# ARCHITECT'S SUPPLEMENTAL INSTRUCTIONS

Date Issued:	May 29, 2020
Project:	Intermountain Healthcare <b>Tooele Valley Dialysis Clinic Expansion</b> 2356 North 400 East, Suite #102 Tooele, Utah 84074
Architect's Supplemental Instructions:	<b>ASI #8</b>
To:	Saunders Construction 1113 South 500 West Bountiful, Utah 84010

**RE:** ASI-008 – Domestic Piping to Sinks -Ref RFI-004

PP101

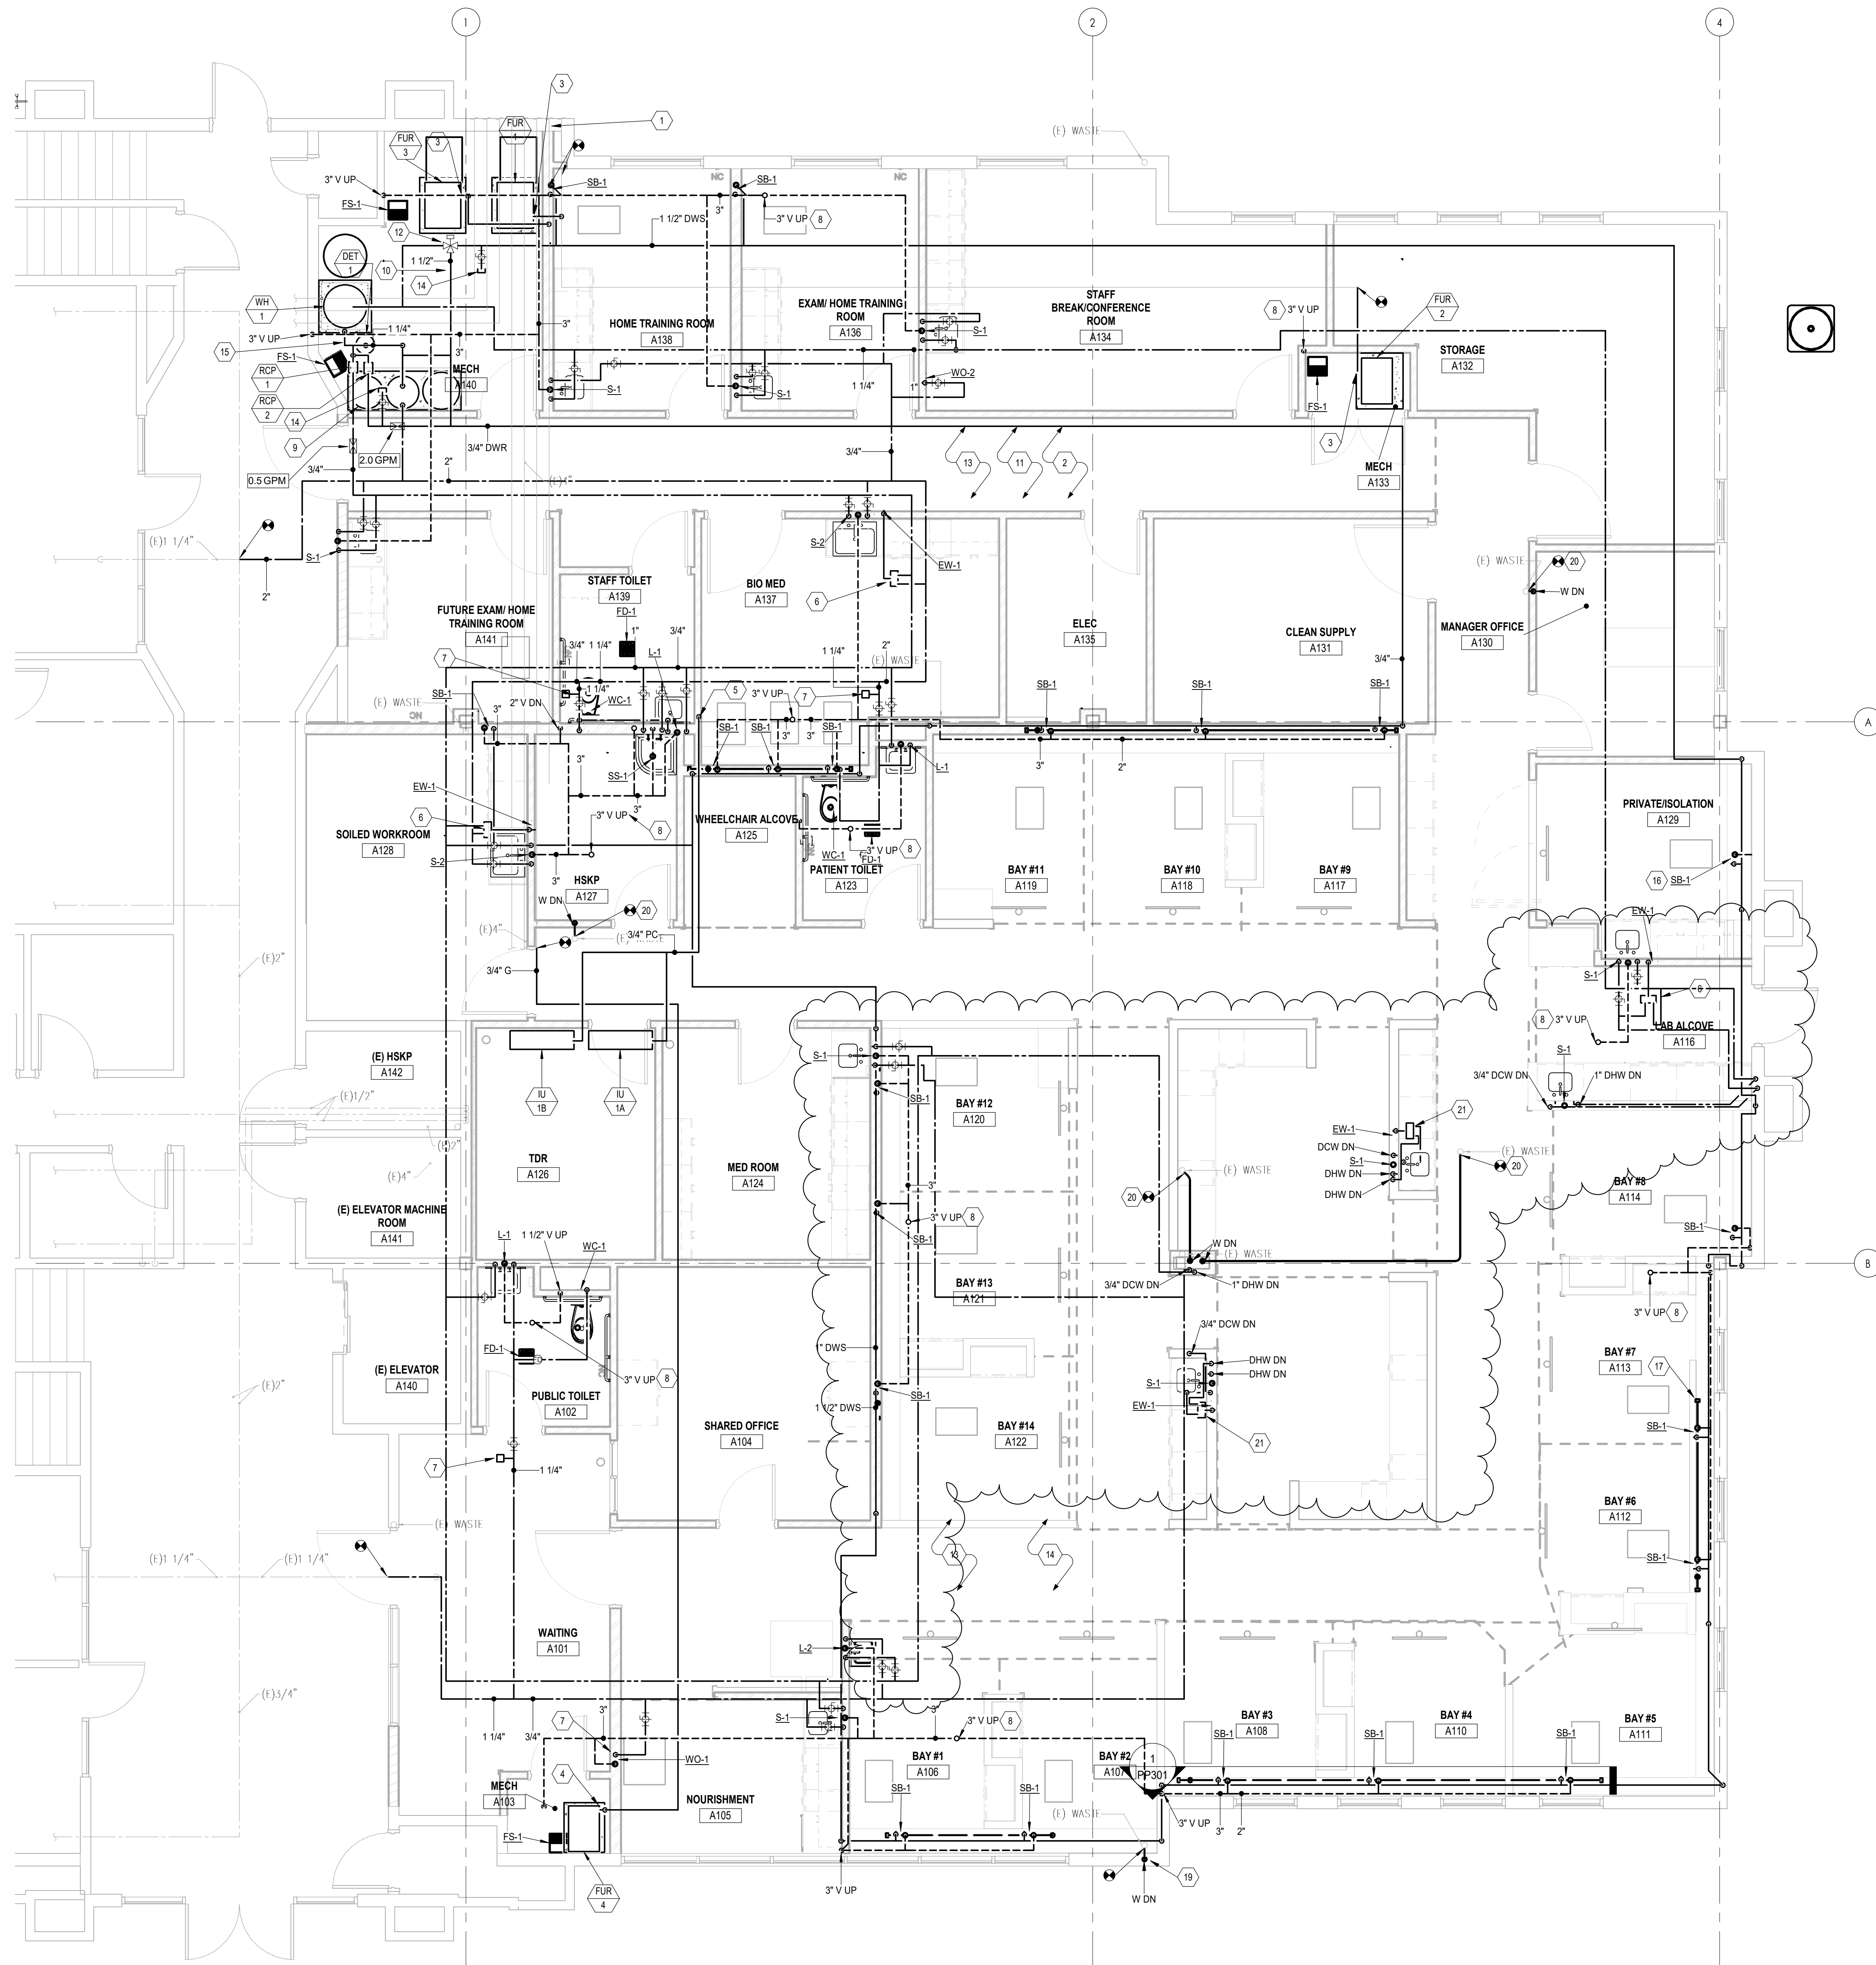
- Vent lines can be common vented per code to the sinks in the following locations: Room A116, Room A122, and Corridor A145.
- Thermostatic mixing valves for EW-1 need to be relocated from the ceiling to underneath the cabinetry in the following locations: Room A122, and Corridor A145.
- Keyed note 21 added.
